SERVICE BULLETIN

NO. A2711-78-2

POWER PLANT - COWLING - HOLD OPEN ROD
REPLACE TUBE RIVETS

FIGURE 1 - TYPICAL A2711 STRUT ASSEMBLY

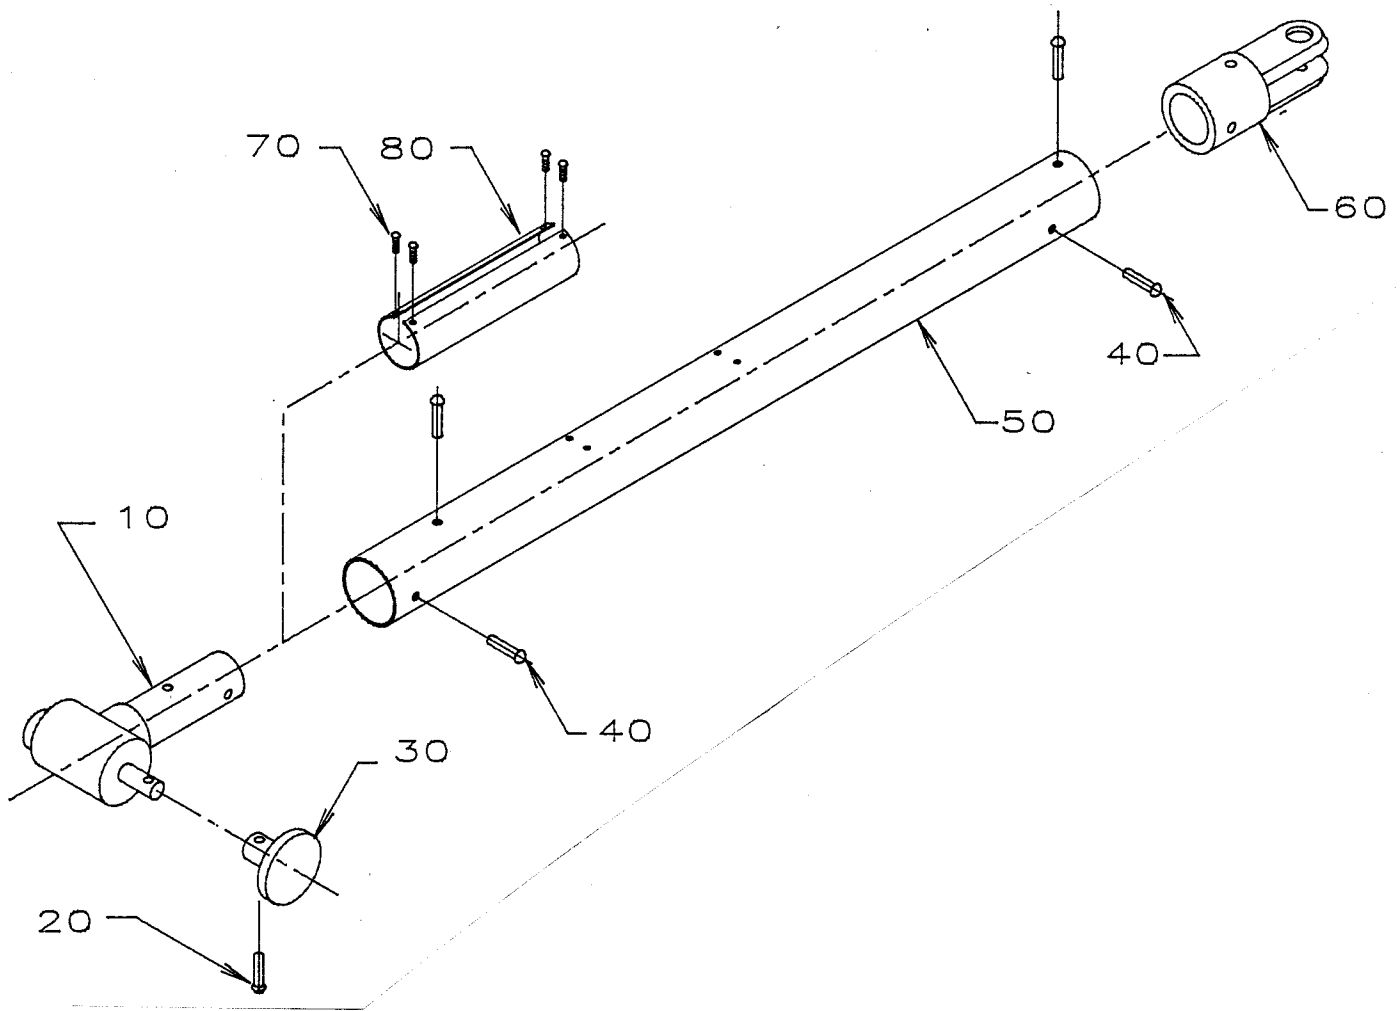
This Service Bulletin provides detailed instructions required for all users to rework Norco part numbers A2711-1 through A2711-11 and A2711-15 through A2711-17. The rework consists of replacing four rivets in the tube with a vibration resistant hex drive bolt and collar. This will allow aircraft operators to replace the end fittings, when required, and quickly assemble the unit with bolts instead of spun rivets.

- A. Drill out two (2) of four (4) MS20613-4C14 rivets, item 40, shown in Figure 1. Select one rivet on each end of the tube (50). Drill through the undeformed rivet head using a 0.125 inch (3.175 mm) diameter drill. Remove the remaining part of the rivet with a 0.125 inch (3.175 mm) diameter punch.
- B. Drill out two (2) rivet holes to 0.166 inch (4.216 mm) using a No. 19 drill. Insert two (2) hex drive bolts, 135C0162-01, in the drilled out holes. Thread on two (2) collars, 130A0164-01, and tighten using a 0.3125 inch (7.94 mm) wrench until the end of the collar shears off. Torque to shear off should be 15 - 25 in. lbs.
- C. Repeat Steps A and B for remaining two (2) rivets.
